5 COMMONWEALTH PARADE, MANLY

PROJECT
THREE STOREY RESIDENTIAL FLAT BUILDING
WITH BASEMENT CAR PARK AT:

5 COMMONWEALTH PDE,
MANLY, NSW

S4.55 LIST OF AMENDMENTS:

FACADE OF 7
COMMONWEALTH PDE

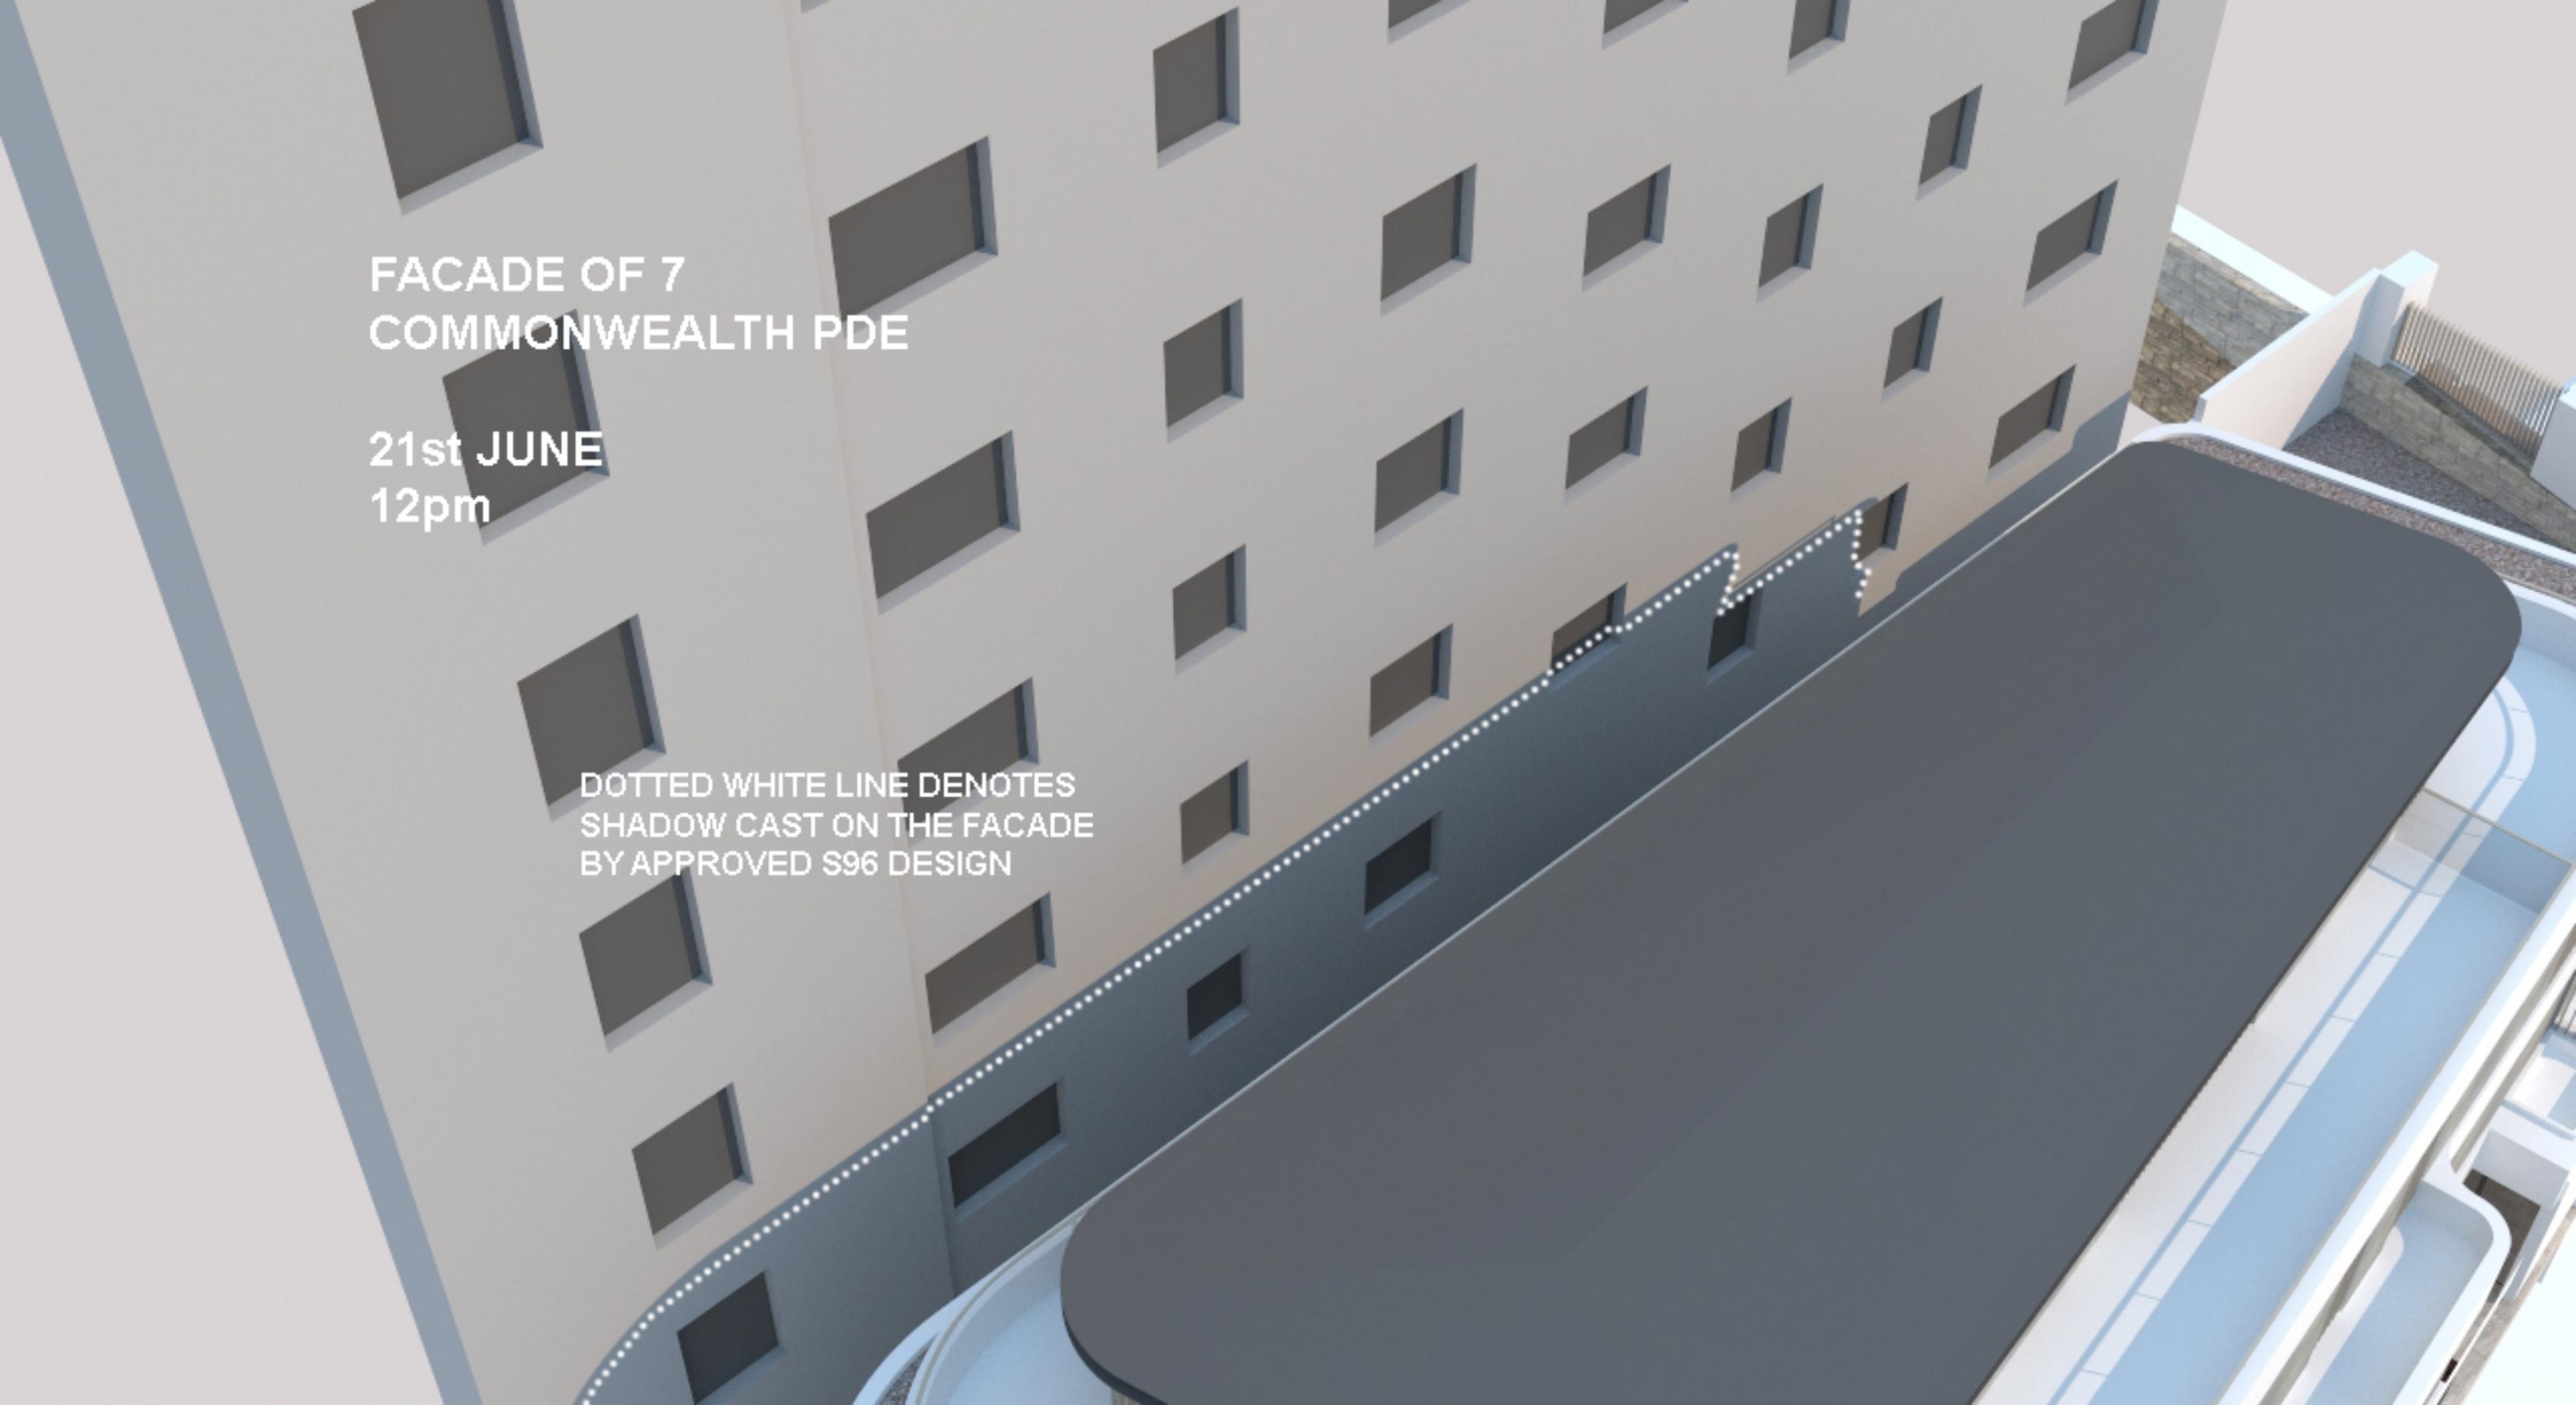
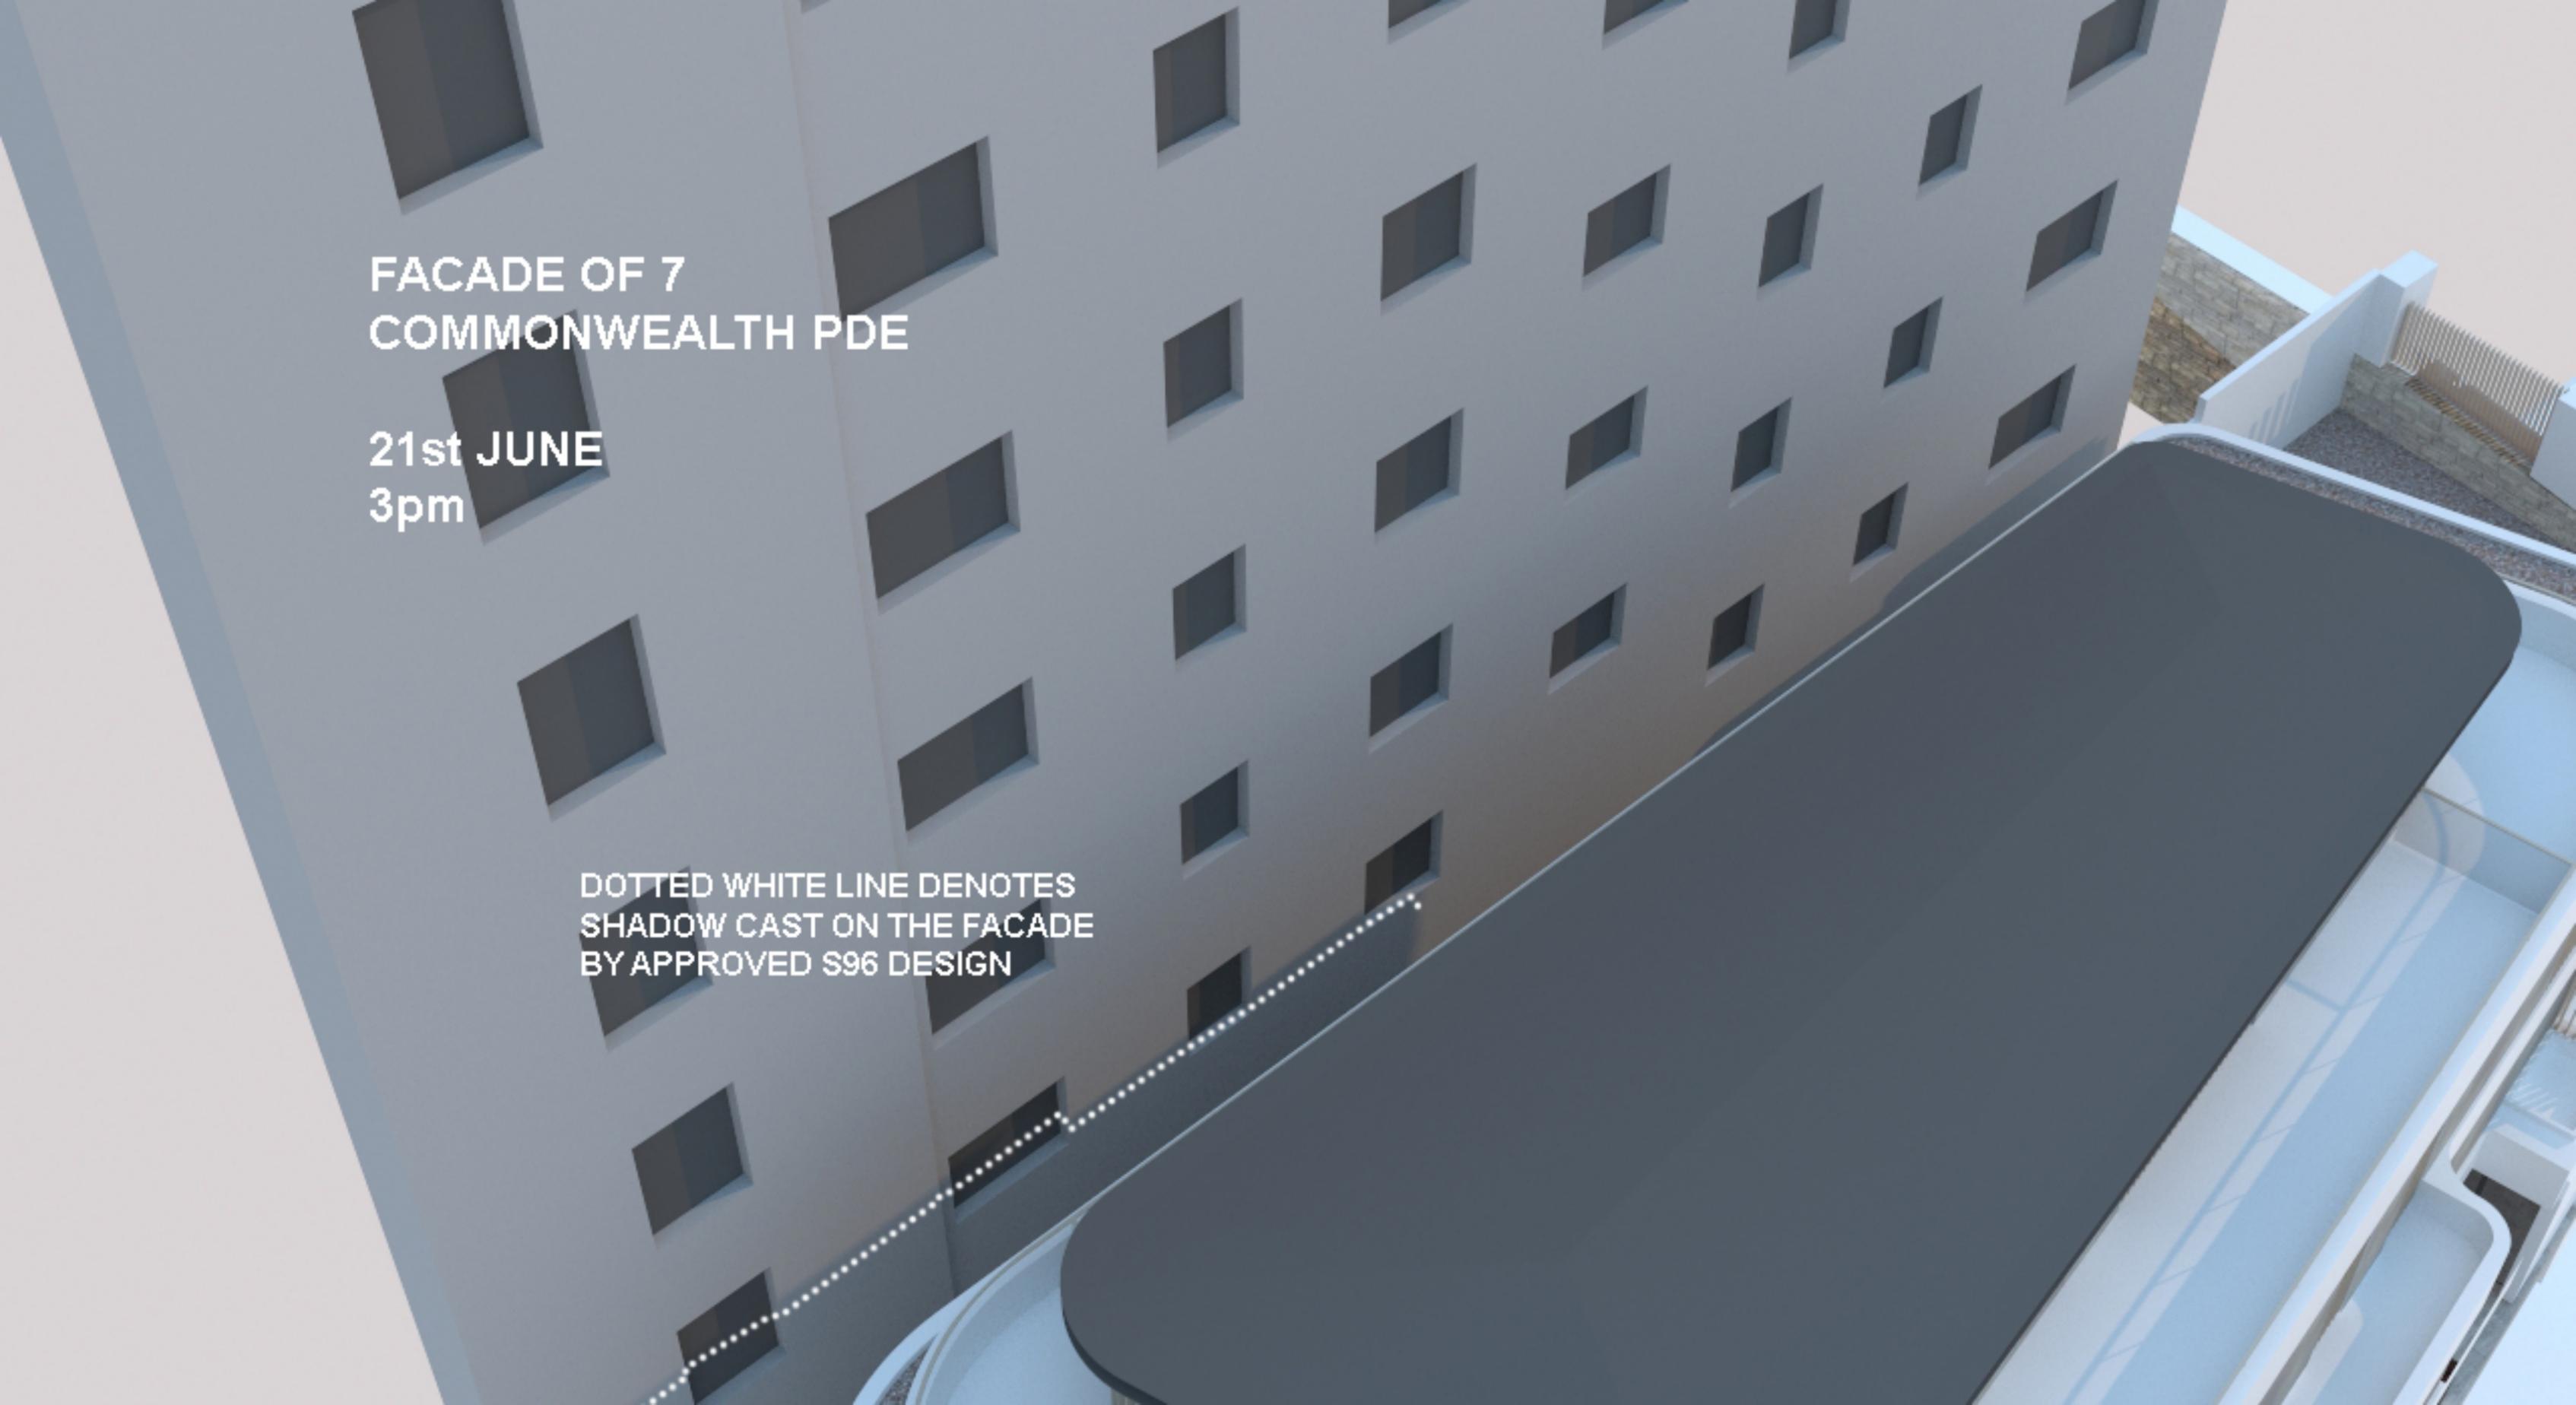
DOTTED WHITE LINE DENOTES
SHADOW CAST ON THE FACADE
BY APPROVED S96 DESIGN
